# UNITED STATES PATENT AND TRADEMARK OFFICE

APPLICATION NO.	FILING DATE	FIRST NAMED INVENTOR	ATTORNEY DOCKET NO.	CONFIRMATION NO.
10/506,675	09/17/2004	Jeannot Hironimus	258372US6PCT	7095
22850	7590	01/10/2008	EXAMINER	
OBLON, SPIVAK, MCCLELLAND MAIER & NEUSTADT, P.C. 1940 DUKE STREET ALEXANDRIA, VA 22314			KOVACS, ARPAD F	
			ART UNIT	PAPER NUMBER
			3671	
			NOTIFICATION DATE	DELIVERY MODE
			01/10/2008	ELECTRONIC

**Office Action Summary**

## DETAILED ACTION

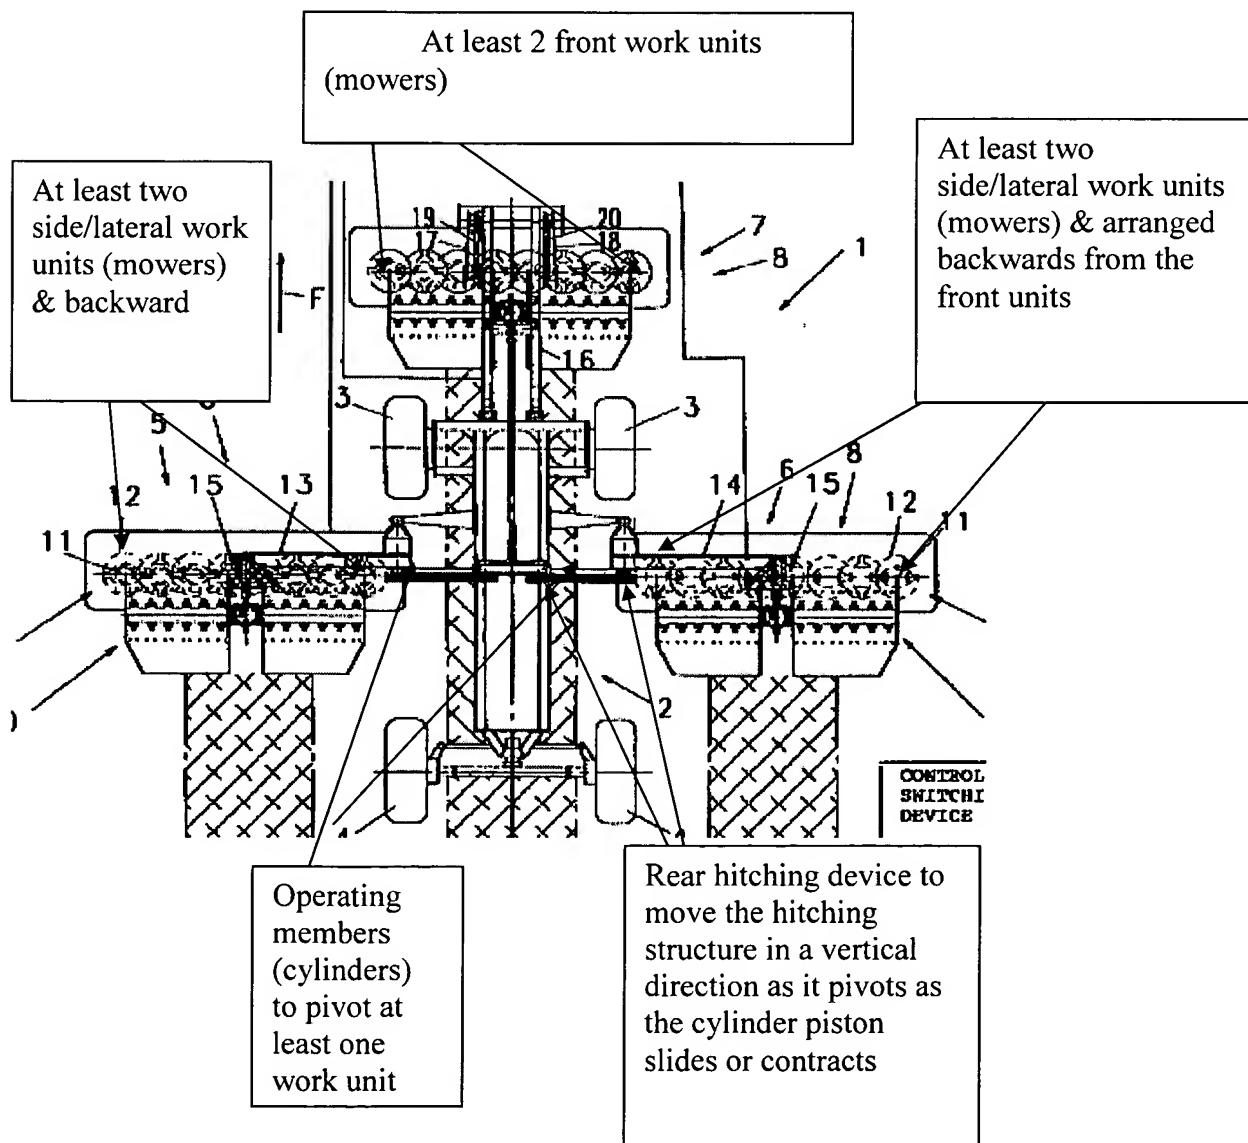
at least two front work units (see drawing below),

at least two lateral work units & outside a work area of the front units (see drawing below);

cl. 30-32, 59-60, 62-64: the lateral/side units arranged backwards from the front units & offset & outside (see drawing below);

cl. 33-34, 38-41: pivoting at least one work unit by an axis in the direction of the forward travel (see drawing below) into horizontal & vertical positions, an operating member or

"The mowing and processing units 8 on either side of the support vehicle 2 are connected to the support vehicle 2 by means of boom and support arms 13, 14, connected in a pivotable and lockable way to the support vehicle 2, and an adjoining articulation 15, and, in this way, they can be moved back and forth between a horizontal working and operating position near the ground surface and a substantially vertical transport position as is generally known in the art."

cl. 42-43: rear hitching device to move the hitching structure in a substantially vertical direction (see fig. above);

cl. 44: the two front work units comprise two front work units (see fig above);

cl. 45: two lateral work units (see fig above);
